## 1) Battery input and DCDC converter schematics

## 2) Output connector board and e-Fuse schematic

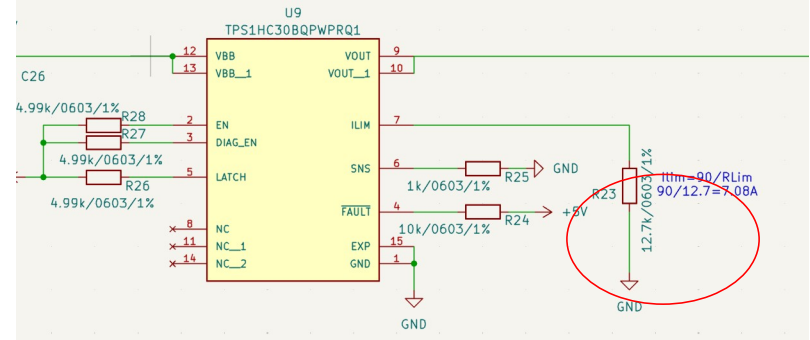
- Suggest 12V DCDC converter output current limit to be reduced to 14A. Mode 2 resistor to change to 200K.
- 12V DCDC converter 22uF low ESR capacitors to be increased from 11 to 12.
- Board output connector (TE 640388-3) mating header (TE 2132189-3) crimps are only rated at 6.5A. Any alternatives? Or should we use solder pads on this board, with a higher rated on the connector expansion board?

1c: Yes, you're right. I didn't check the crimps. I've found a more suitable option from Molex:

Header: 2165711003

Housing: 2157591003

Crimp: 2064600041

Electrical	
Current - Maximum per Contact	13.0A
Physical
